ADDENDUM NO. 03

**Baggage Screening Improvements – Phase 2B**  
**[Baggage Handling Building Addition and OSR Room]**

PROJECT NO. A044-09002-02

DATE OF ADDENDUM: February 10, 2012

**S101B**

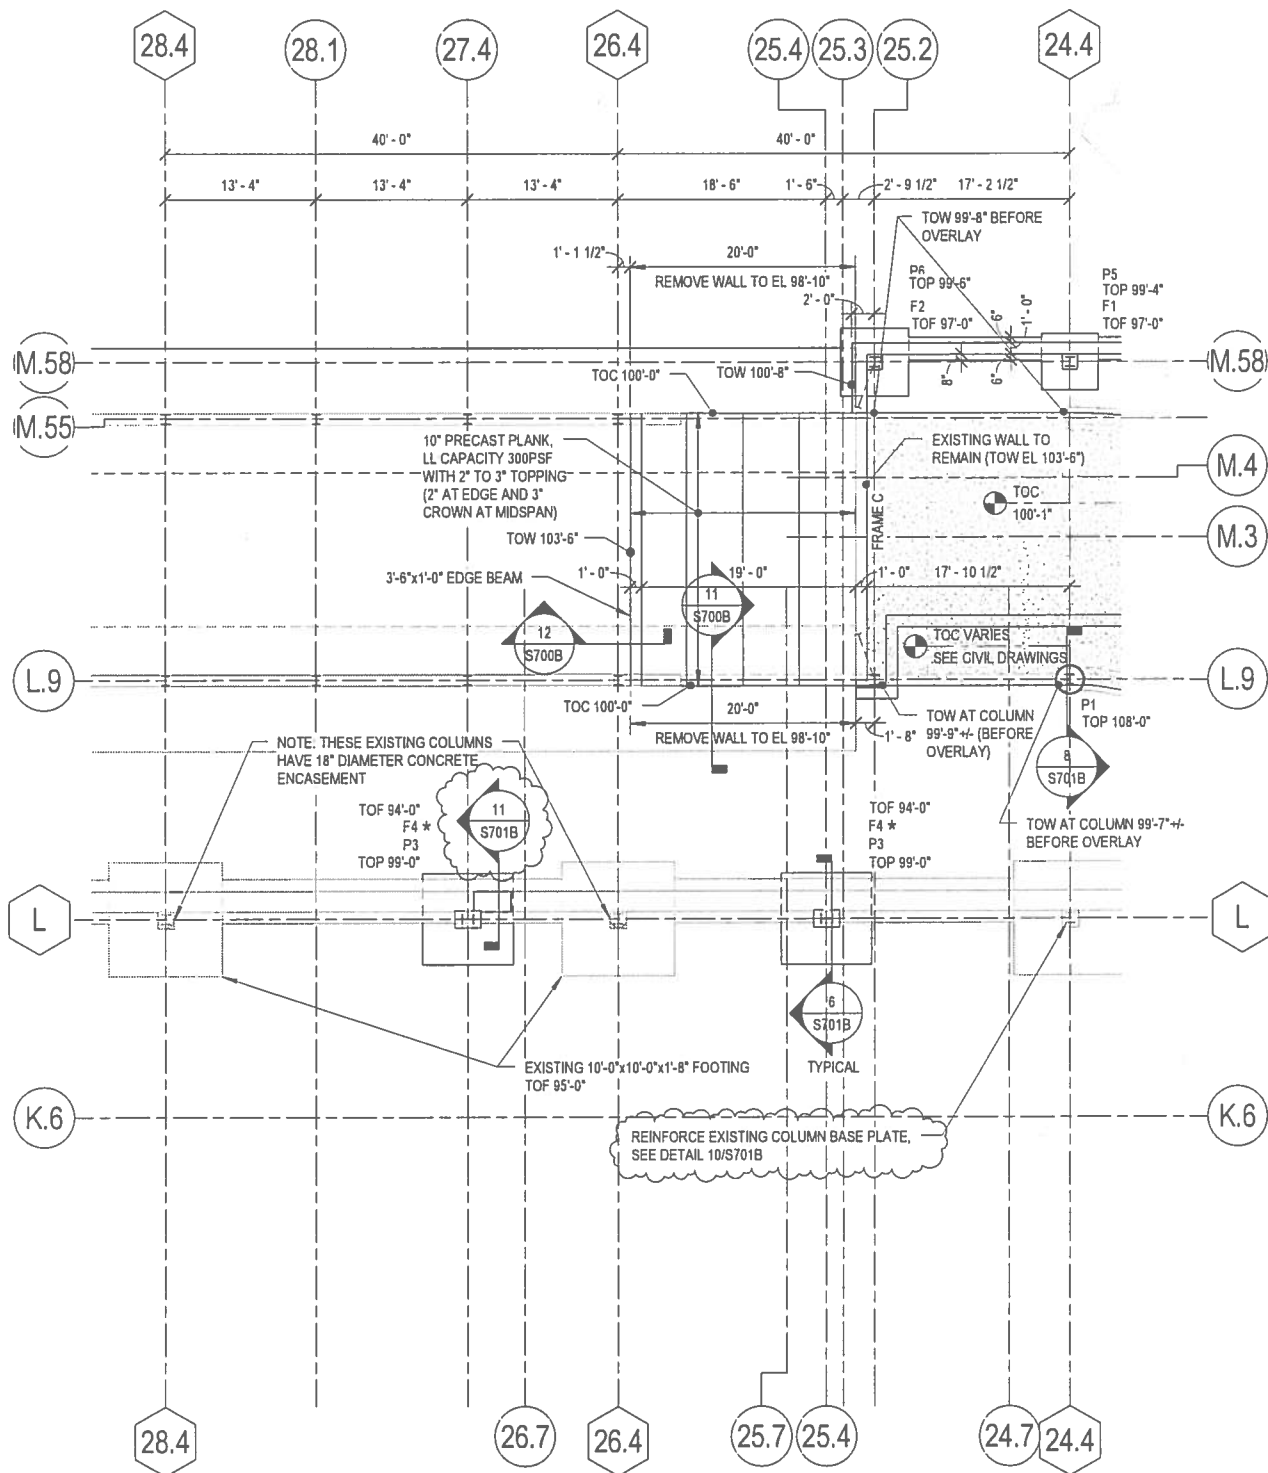
**CHANGE** section cut near column L-27.4 **FROM** "11/S710B" **TO** "11/S701B". **CHANGE** detail call out at L-24.4 **FROM** "10/S710B" **TO** "10/S701B". (see attached drawing)

**E103B**

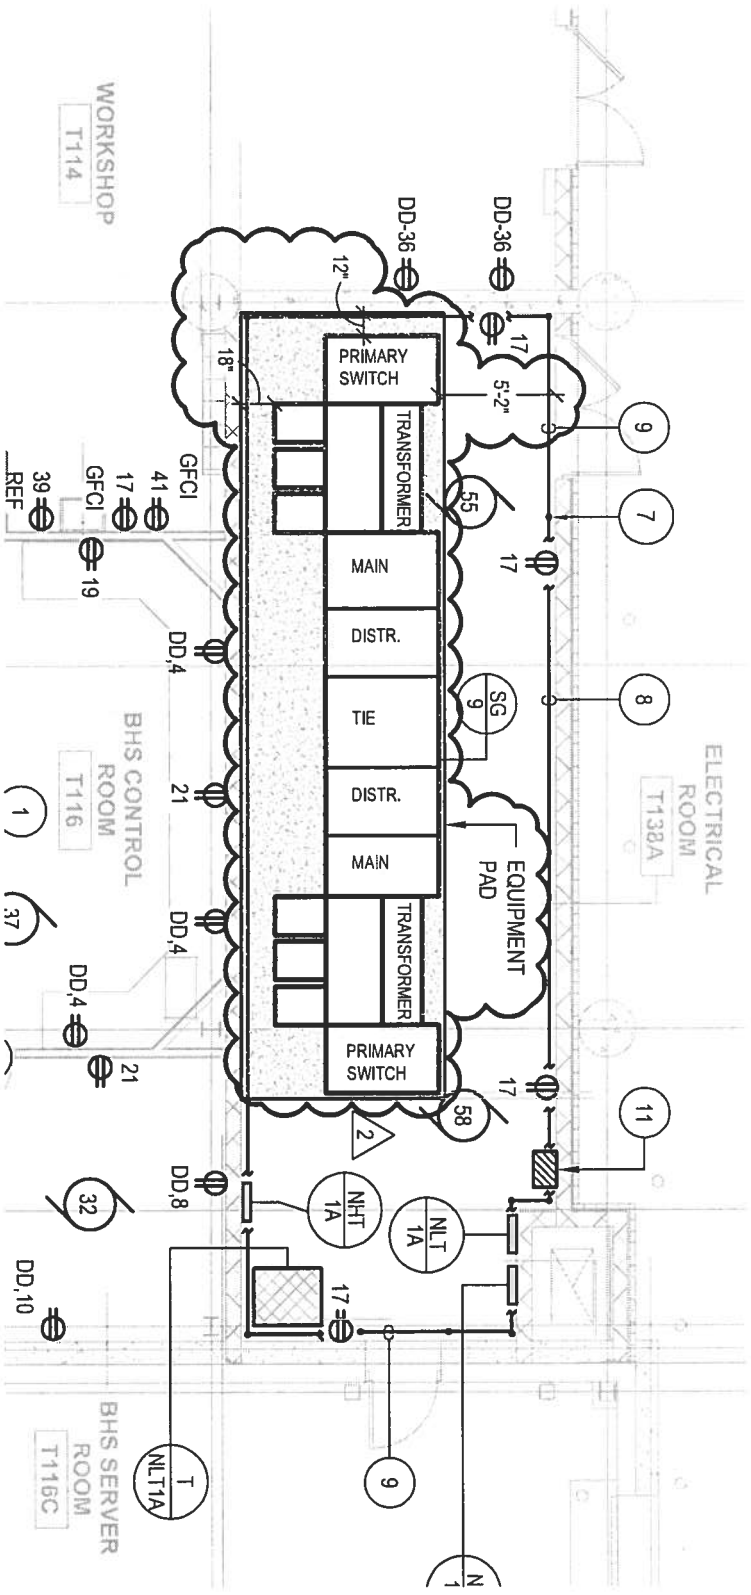
**SHEET E103B: CHANGE:** Detail #2 as shown on attached drawing.

PARTIAL GRADE LEVEL PAVING PLAN - NORTH ES301B

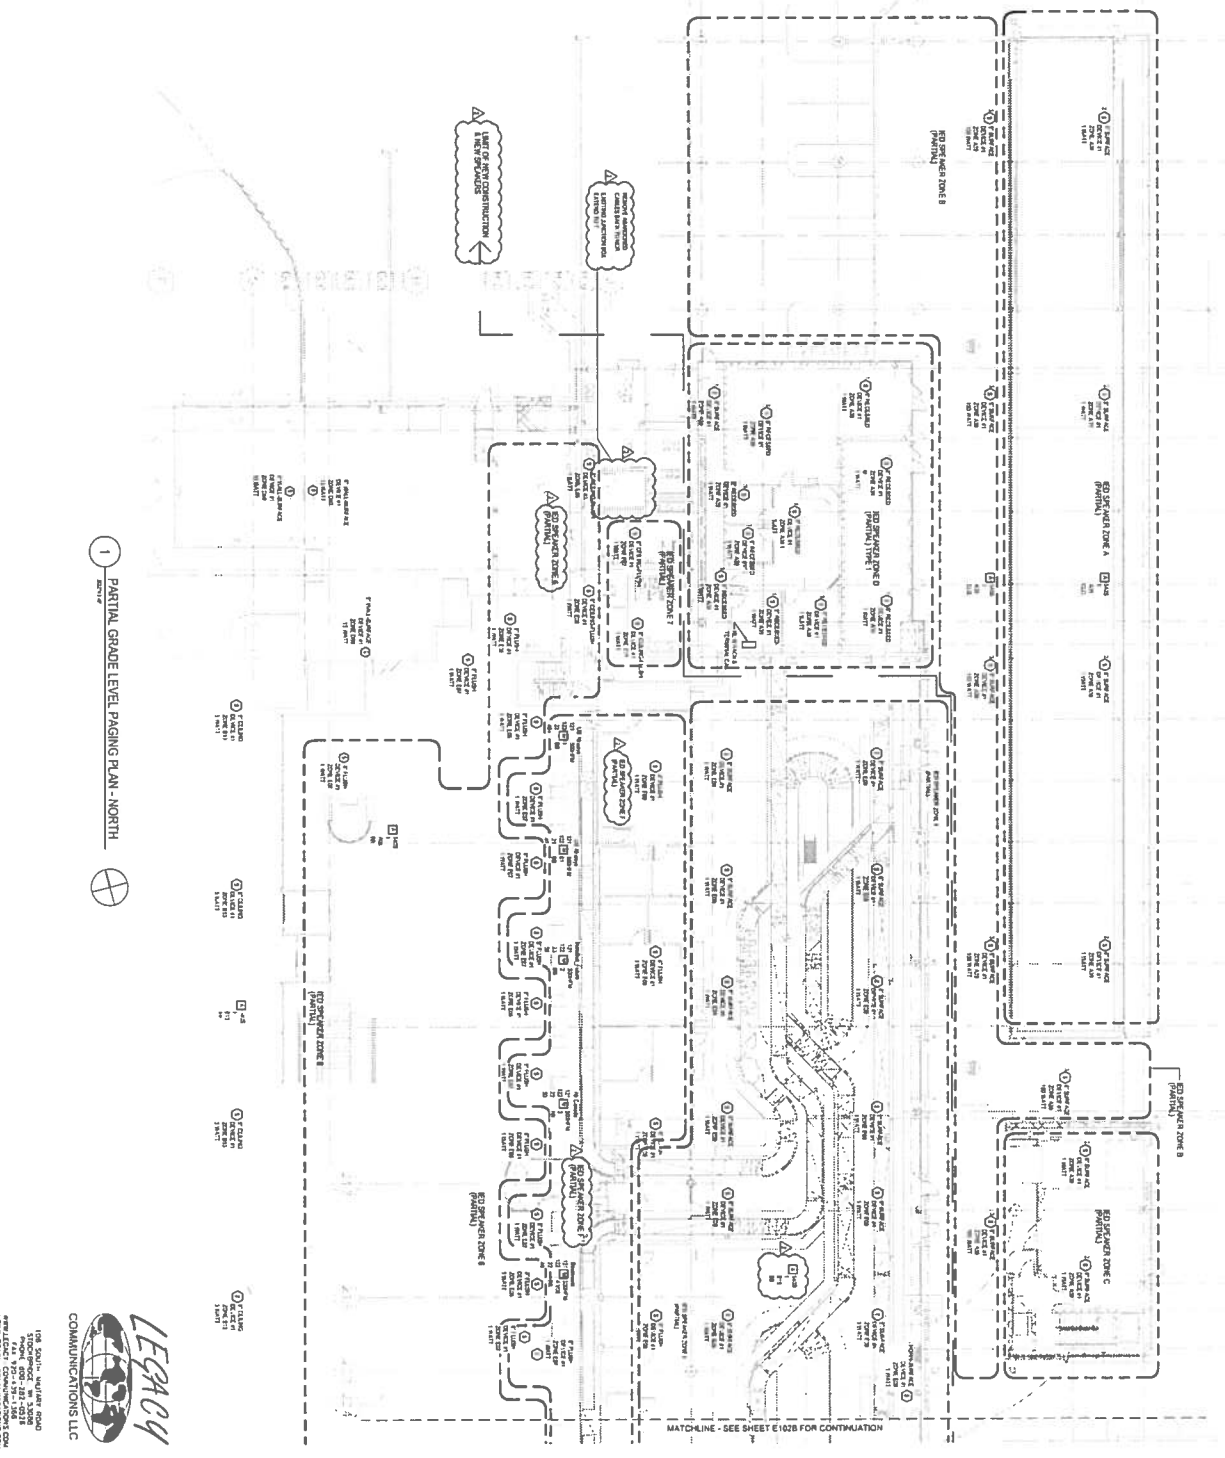
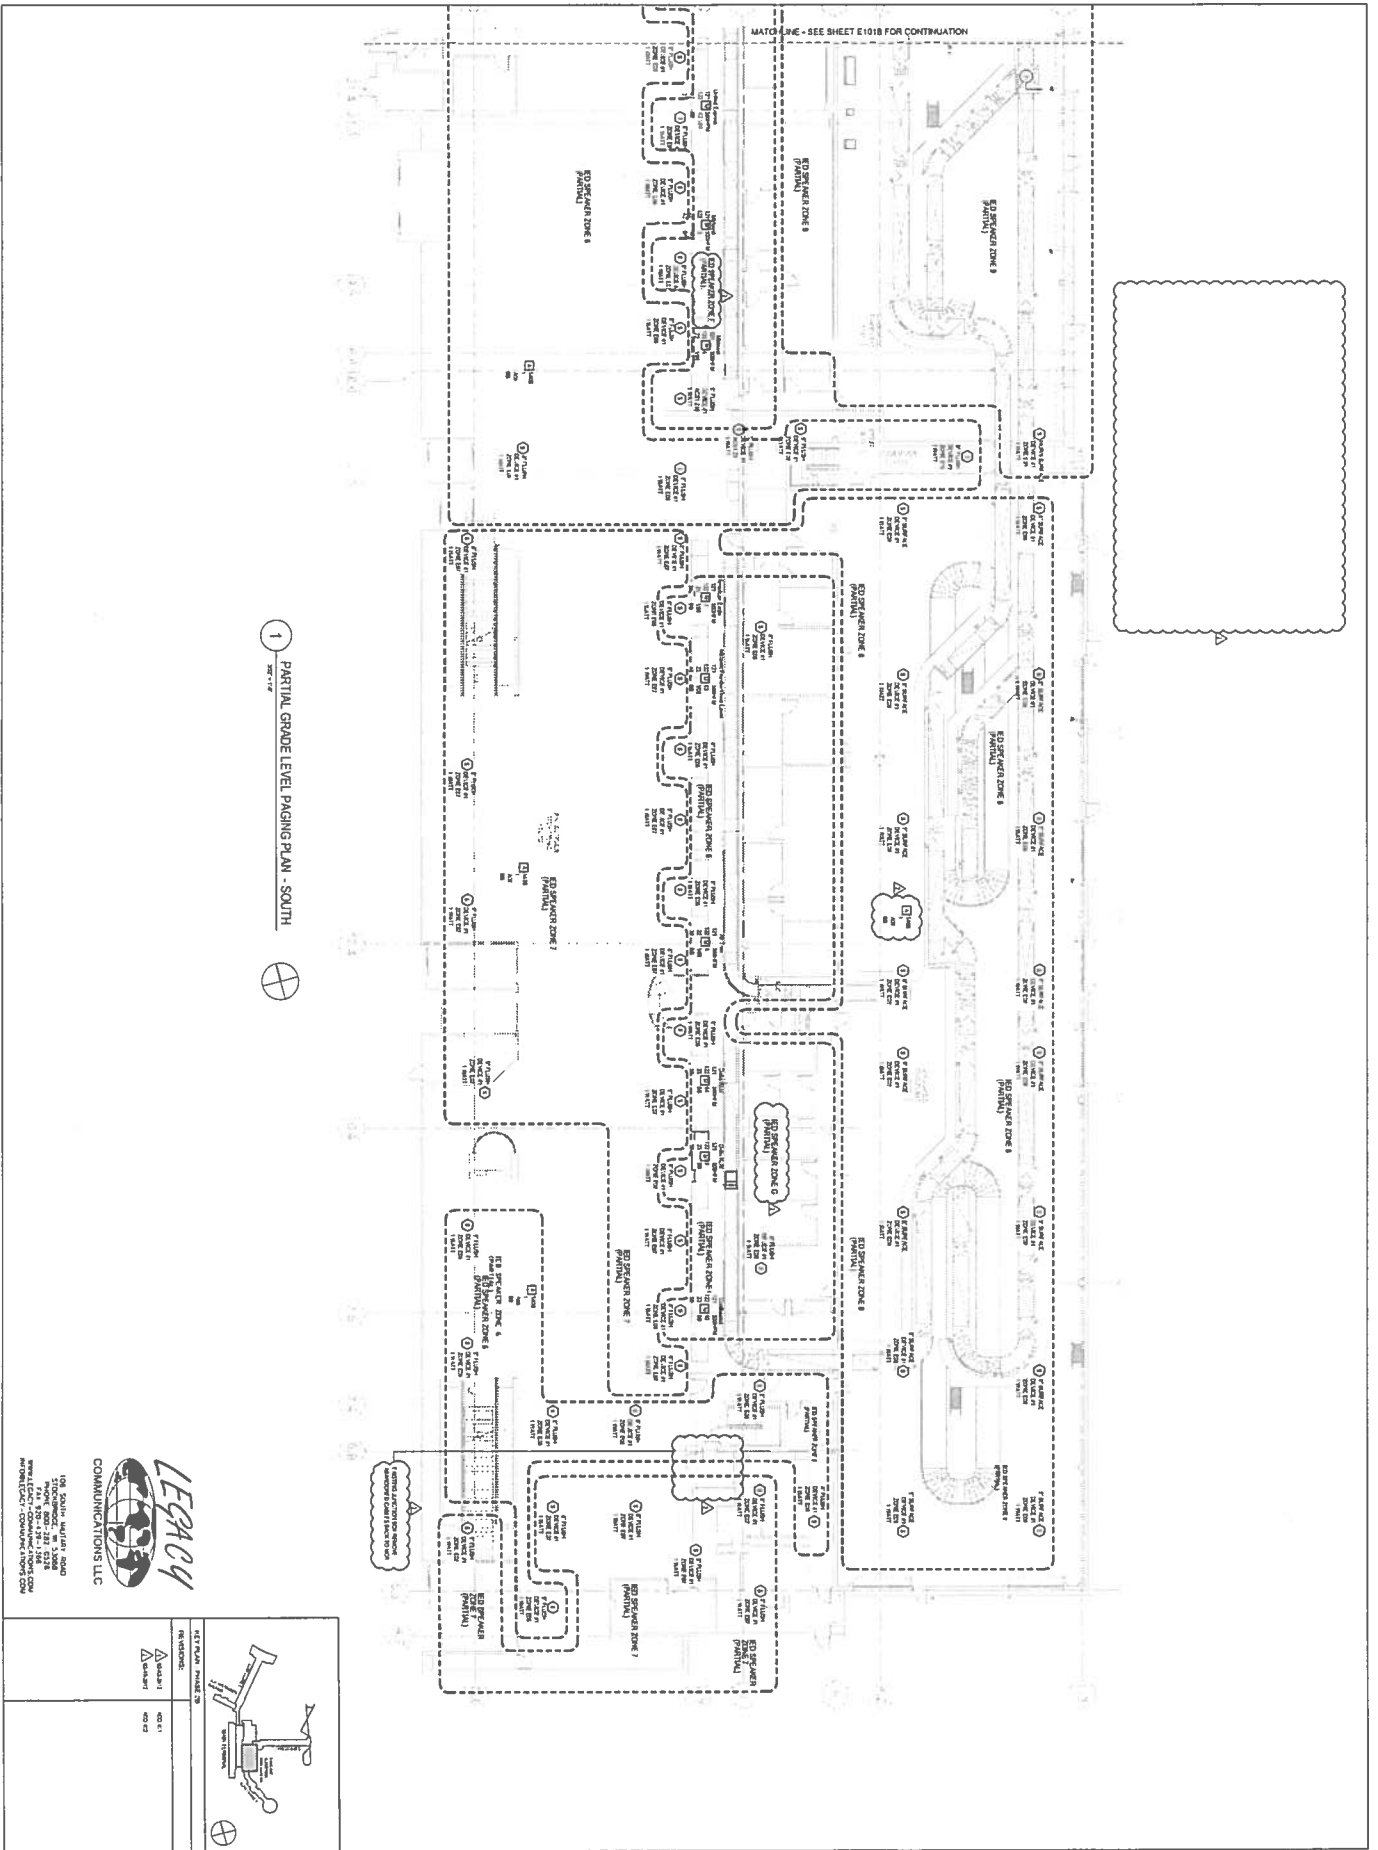
**SHEET ES301B, ES302B, ES401B, and ES402B: ADD** Limits of construction and modify speaker devices as shown on full sized sheets. (attached)
